July 10, 2015

Re: Proposed Rule Energy Conservation Standards for Residential Furnaces;
Docket Number EERE-2014-BT-STD-0031

SUMMARY OF COMMENTS

Figure 6: "Winners" and "Losers" Predicted by DOE

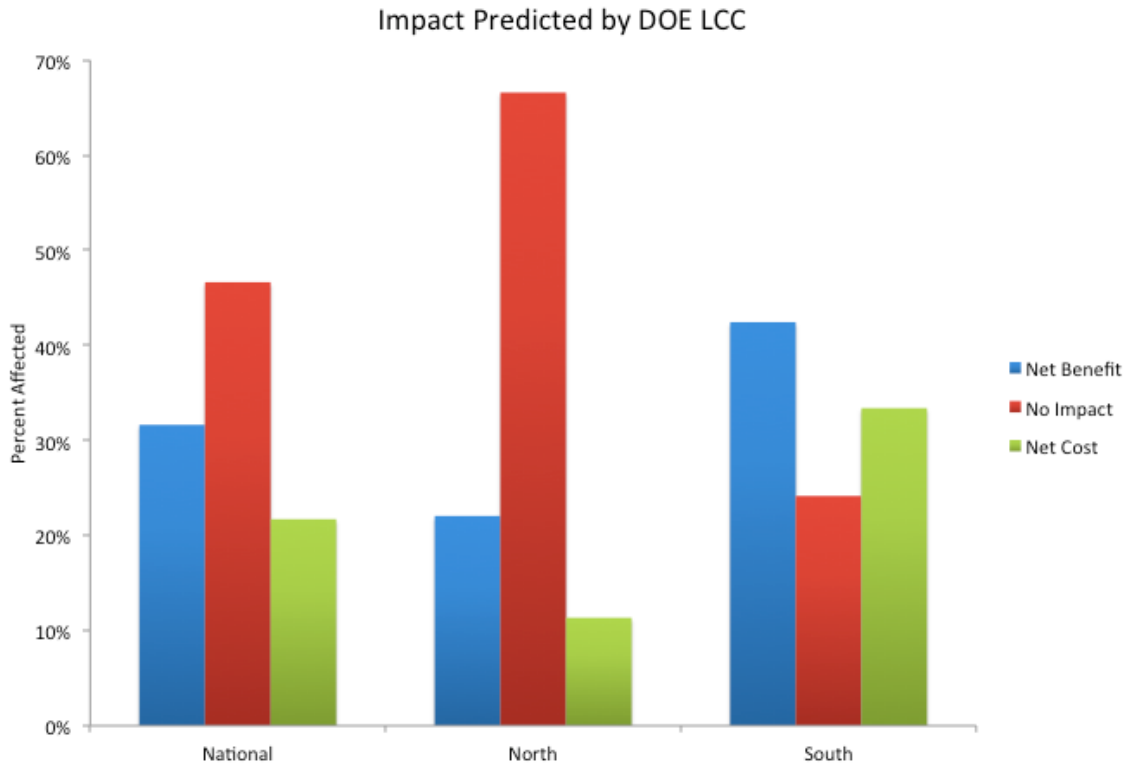
These analyses appear to show that the proposed standards are benign since most households in the North are unaffected and a plurality in the South benefit (Figure 6). In actuality, these results essentially reflect the assumed share of condensing furnaces in the Base Case. The “No Impact” result is obtained when the Base Case and the Standards Case are the same, i.e. when the Base Case already assumes that the homeowner is planning to purchase a condensing furnace. DOE assumes that condensing furnace share in the Base Case is National: 47%, North: 66% and South: 25%.⁴⁵ These are the values that appear in the “No Impact” charts.

These results do not mean there is a benign “No Impact”, it means that these purchasers are being arbitrarily assigned to Group 1: Purchase Anyway without any regard to the actual economic returns to them or to any of the other purchasers who are excluded from this group. In reality, any reasonable characterization of marketplace behavior would expect that the high positive life cycle cost savings shown in the 70th to the 90th percentiles would be in the “No Impact” category. Because of random assignment, DOE is arbitrarily assuming that consumers are acting counter to their economic interests. It is assuming the conclusion it is trying to prove. While this may be comforting to an analyst or an advocate, it is not a piece of serious thought. Rather it is being arbitrary and capricious in its use of analytical tools and data. In any serious analysis, the “No Impact” portion of would shift to the far right of the graph so that the large positive life cycle cost savings now shown in that chart would be replaced by smaller or negative savings.

Figure 13: DOE Assumed Consumer Discount Rates

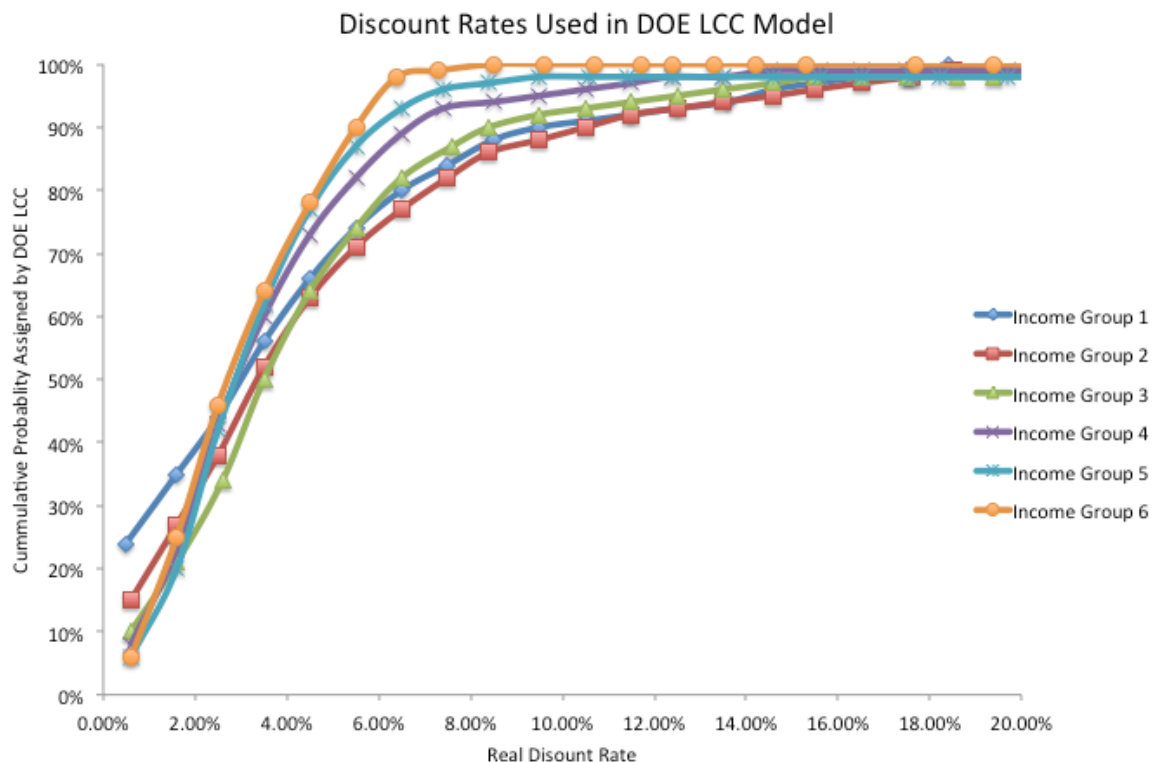
In this context, the DOE assumed real discount rates appear to be improbable representations of the actual financial situations faced by consumers. In its LCC, DOE has average discount rates of (Figure 13):⁵⁹

The true marginal discount rates for consumers are much more likely to cluster around 8-9% than around 3-5%. First, as demonstrated by both reasonable analysis of consumer balance sheets and the survey data, only a minority of consumers will be able to use cash or other savings in order to pay for a furnace replacement. Even then, cash is not a low/no cost source of funds since it must be replaced with high cost funds or deferred consumption in order to rebuild the liquidity cushion. The marginal source of funds for most consumers is credit card debt (estimated by DOE at 14.2-15.0% interest rate)⁶⁰. According to the American Housing Survey, only 7% of respondents had home equity loans or lines of credit (the lowest cost of borrowing for most consumers).⁶¹ (While home mortgages are also a low cost source of funds, the transaction costs and time for refinancing a mortgage make first mortgages an unlikely source of funds for a furnace replacement.) A small portion of households in Income Groups 5 and 6 may be able to finance a furnace replacement by drawing on non-retirement savings. However, these will also have a cost of funds estimated by DOE at 4.2% for debt to 9.2% for equities.⁶² While this may yield an average cost of consumer capital below 8-9%, it is unlikely that DOE wishes to justify standards on the ability of the upper 10% of consumers to finance them at relatively lower costs of capital.

Figure 14: DOE vs. Contractor Survey Furnace Installation Costs – North

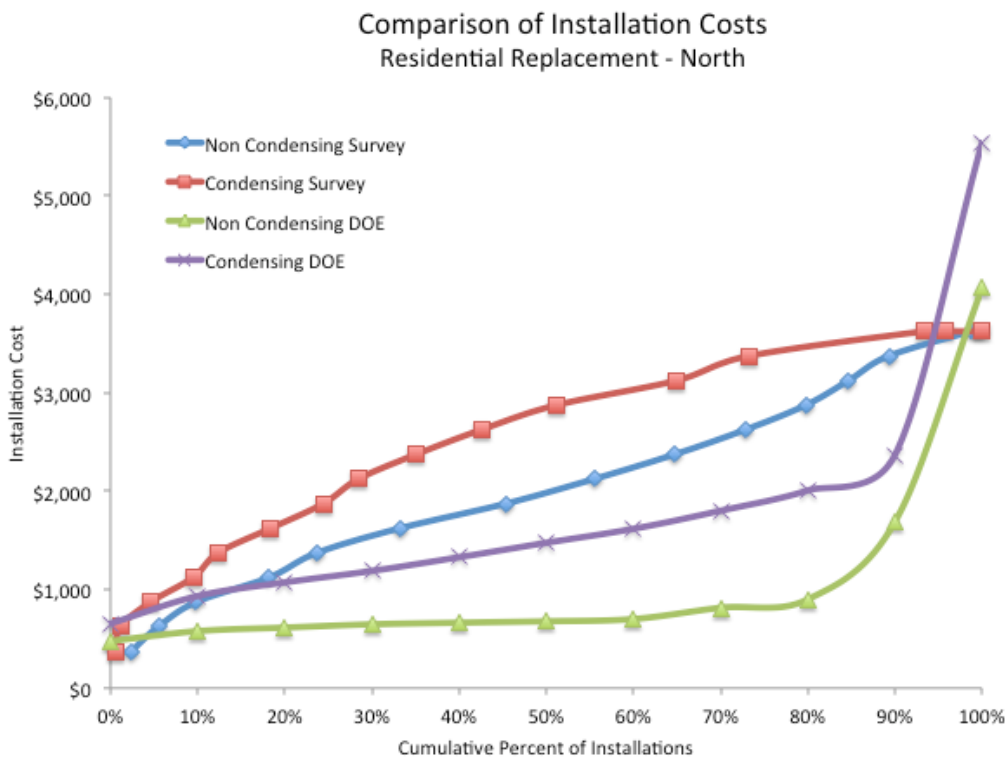
The mean costs for the DOE data are distorted by high outlying values.

The total distribution of costs shows a consistent pattern of DOE underestimating the cost of installation (Figure 14 & Figure 15).

Figure 19: DOE Furnace TSD Figure 8C3.3

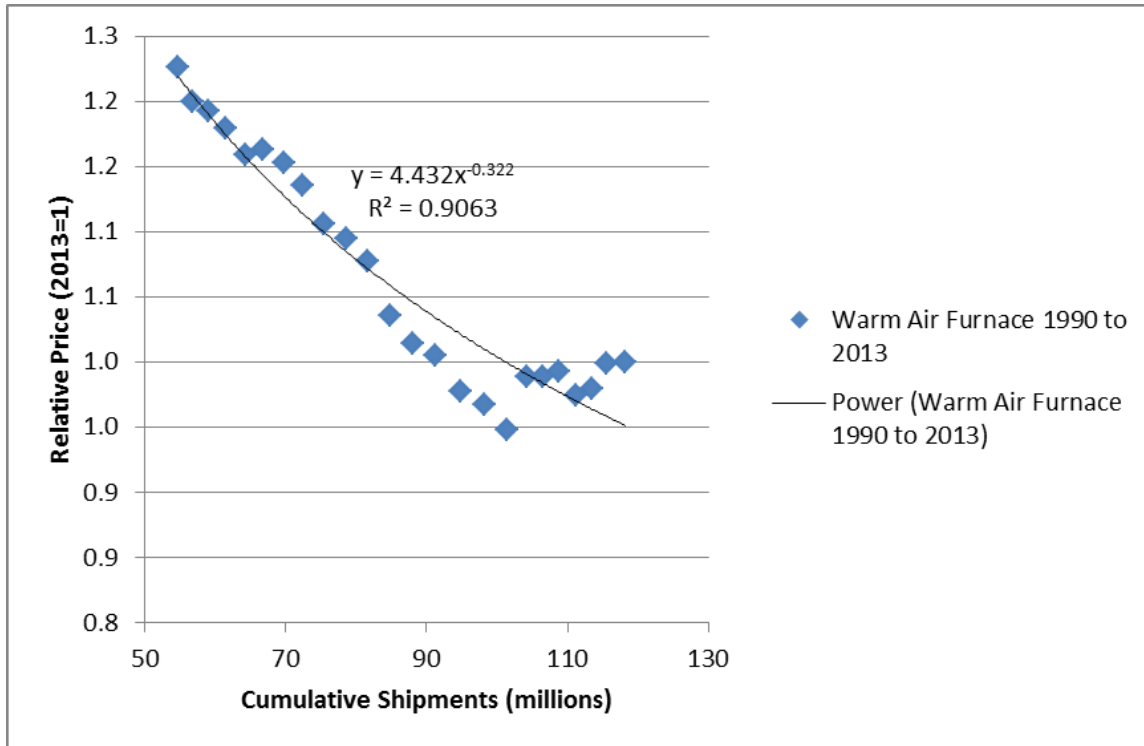
The importance of data and taking it as it comes can be seen through Figure 8C.3.3 in the Furnace TSD (Figure 19). It appears that there has been a structural change in the price/shipment relationship for the final seven data points. DOE chose to fit a single curve through all its data points rather than the more obvious solution of starting a separate curve for the final seven. Victor Franco, for DOE, stated: “we fit basically, we do the best fit to that curve.” By inspection (Figure 20), there would be a better fit by drawing two curves. One would go through the last seven data points and one would go through the others. However, this can only be inferred by inspection since DOE has not responded to AHRI’s request to release the actual numerical data behind the graphs.⁷¹

Based on the empirical evidence, there appears to be a new relationship building. DOE attempts to discount this data by saying “part of those values are distorted by the market”⁷² referring to earlier comments in the public meeting referencing the presence of tax credits. Andrew Delaski made the same point also during the public meeting:

Figure 21: LCC Projected Fuel Use for 80 AFUE Furnaces

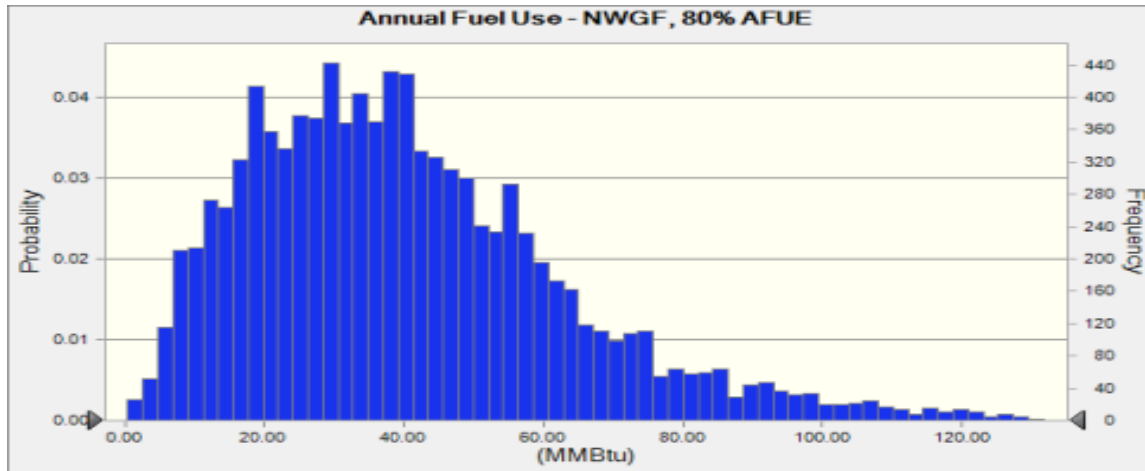
There is also something quite odd in the calculation of Annual Fuel Use. As can be seen from the graphs, the fuel use for 80 AFUE furnaces has a plausible distribution (Figure 21):⁸⁰

Figure 22: LCC Projected Fuel Use for 90 AFUE Furnaces

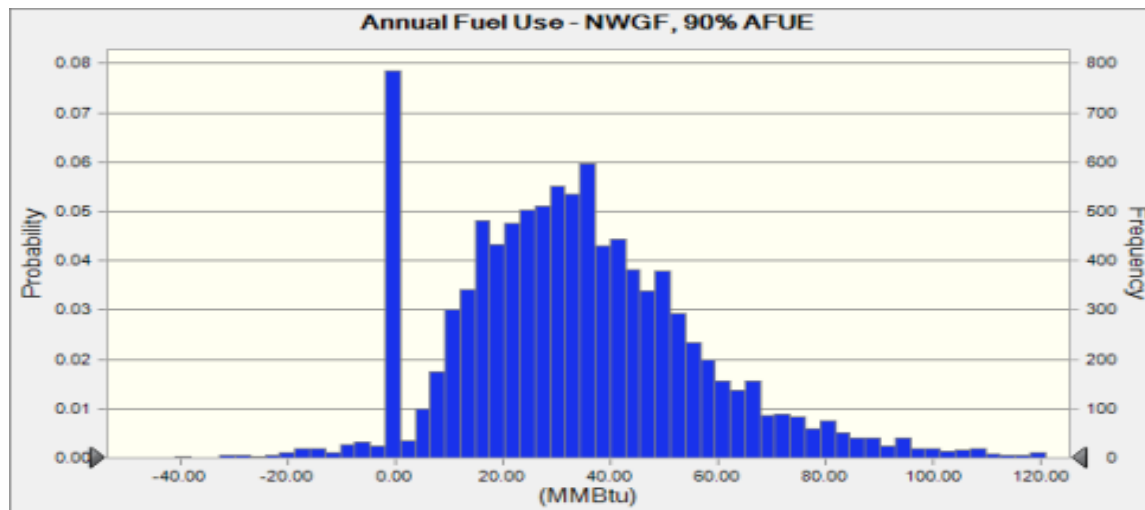
However, the fuel use for 90 AFUE furnaces has a very odd distribution (Figure 22):

Again, while it is not practical to debug the LCC model, the large value at zero fuel use and the negative values are highly unlikely to be real reflections of actual conditions. The negative fuel uses are unlikely to represent gas wells on peoples' properties. Something is significantly wrong with the DOE LCC model if it is projecting zero and/or negative fuel use.

Figure 26: Implicit Example of Ordering Issue for NIA Analysis

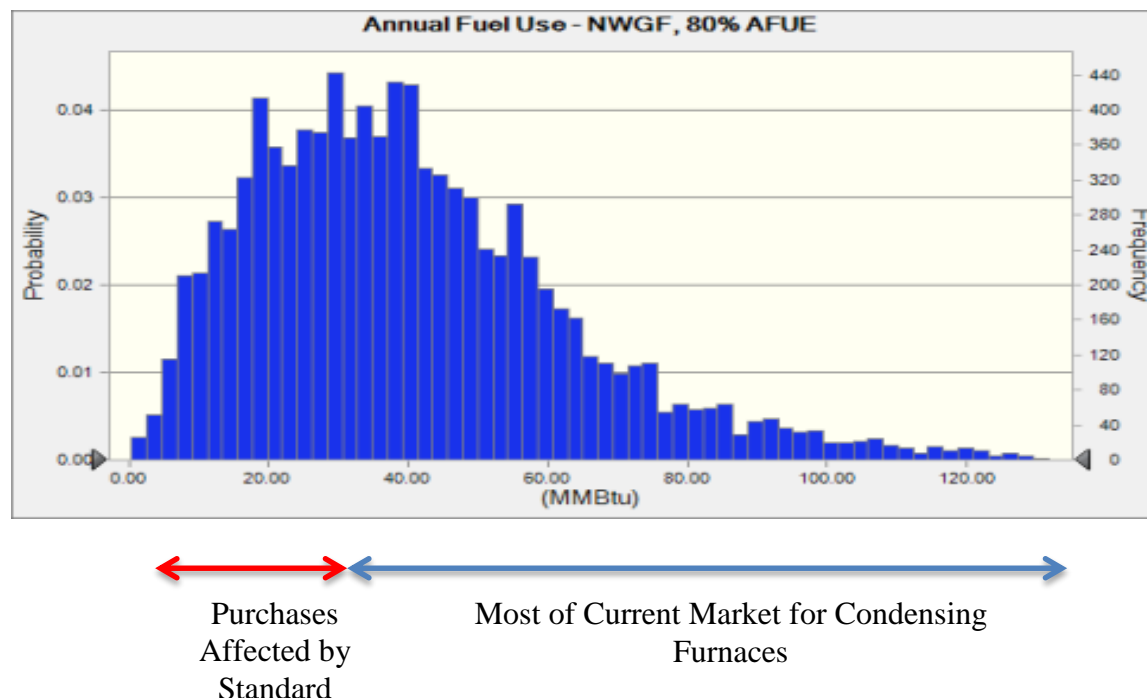
This effect results in an over estimate of the energy savings by the difference between the average for the total distribution of energy consumption and the average for the lower 50% of consumption (since the current market share of condensing furnaces is approximately 50%)(Figure 26).⁸⁷

It is difficult to determine exactly how significant this mistake is since the random selection process compromises distributions of energy use and the savings estimated in the LCC. A reasonable first approximation is to take the energy use for the 25th percentile of the 80 AFUE furnaces as the average for the consumption affected by the standard and compare it to the energy use by the median 80 AFUE furnaces that underlies the actual NIA calculations:
